DOCKET #: W2637

PROPOSED ZONING:
Site Plan Amendment

RE: ZONING MAP AMENDMENT W-2637

ZONING STAFF REPORT

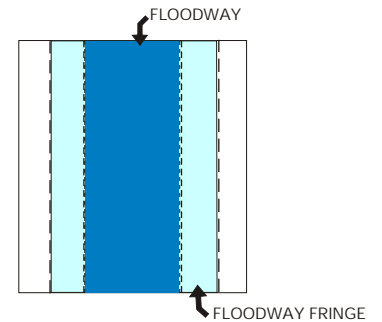
The current request is a Site Plan Amendment for 70.03 acres within 239.72 acres of RM-5-S land. The site generally is located on the north side of Kernersville Road and southwest side of Linville Road. This site plan amendment is for land accessed from Linville Road and also abutting Emily Drive. Development in this area is primarily residential in character with a church located at the intersection of Emily Drive and Linville Road. The subject property is currently undeveloped.

The site plan amendment has two fundamental changes to the original plan. The first change is to switch Phase 1 and 2 of development. Originally, Phase 1 would have been the commercial and mixed residential component accessed off of Kernersville Road. The current request switches Phase 1 to the residential component near Emily Drive.

The second and more fundamental requested change is to deviate from 140 single-family (SF) units and 67 townhouses (total of 207 units) to a total of 180 SF units. Currently, there are no proposed changes to the other phases of development although the current petitioner does not control the land for the other phases. All of the proposed 180 units are to be placed on 55-foot wide lots.

Beyond the two primary changes in the plan, there are other elements absent from the present request that appeared in the previous approval. Many of these elements contributed to the overall atmosphere and common theme of the previous design. Such elements were traffic calming devices, public focal points and gathering spaces, and most of all, the presence of mixed residential housing choices.

As presented, all vehicular traffic within the 70.03 acres of the site plan amendment would have one way in and one way out of this first phase of development. Upon the completion of the entire project, the tree lined drive of River Farm Road within this first phase will be the only access to Linville Road. Two other opportunities for connectivity exist, as it pertains to the site plan amendment.

A connection to Emily Drive would provide an alternative route to access Linville Road. Although the connection to Emily was taken out of the original plan by action of City Council, the nature of the development proposed has now changed to all single family. Standard subdivisions are required to be interconnected. Based on the proposed plan, taking this route would seem practical for only about ¼ of the 180 proposed single-family residents.

Another potential connection to the subject property could occur at the northern property line to a street stub right-of-way off of Longworth Drive. This connection was not entertained with the previous site plan due to the fact that no residential units were proposed within 400 foot of this northern property line. This distance was maintained on the original plan by not having housing cross over a natural draw, or large ditch. Now, the plan shows lots abutting this northern property line. Although the Site Plan Amendment is part of a special use zoning district, this phase as proposed is essentially a single family subdivision and consistency would suggest following all requirements of the adopted subdivision regulations including street connectivity.

In conclusion, the proposed site plan amendment does very little to uphold the intent of the approved rezoning. Many aspects originally proposed, that help to give the development identity and cohesion such as community focal points and/or gathering spaces, traffic calming devices and a central community facility have been eliminated. Furthermore, a mixture of housing types has been replaced with a homogeneous landscape of nearly identical lots, undermining opportunities for diversity and housing choice. The proposed site plan amendment represents a significant change in the character of the development that will likely impact the viability of the remainder of the acreage under the approved plan.

Zoning: **DENIAL.**

Site Plan: Staff certifies that **the site plan meets all code requirements**, and recommends the following conditions:

- b. Dumont Drive shall terminate at its present location and shall not be extended into the Mt. Vernon development.
 - c. The western terminus of Emily Drive shall be open to accommodate access to the subject property.

MOTION: Arnold King moved approval of the zoning map amendment, certified that the site plan meets all code requirements and recommends staff conditions without the requirement for connectivity.

MOTION: Arnold King amended his motion to recommend approval of the zoning map amendment, certified that the site plan meets all code requirements, recommends staff recommendations without the requirement for connectivity to Emily Drive and required the southern traffic circle to be installed at the appropriate time with the developer and staff working out the details.
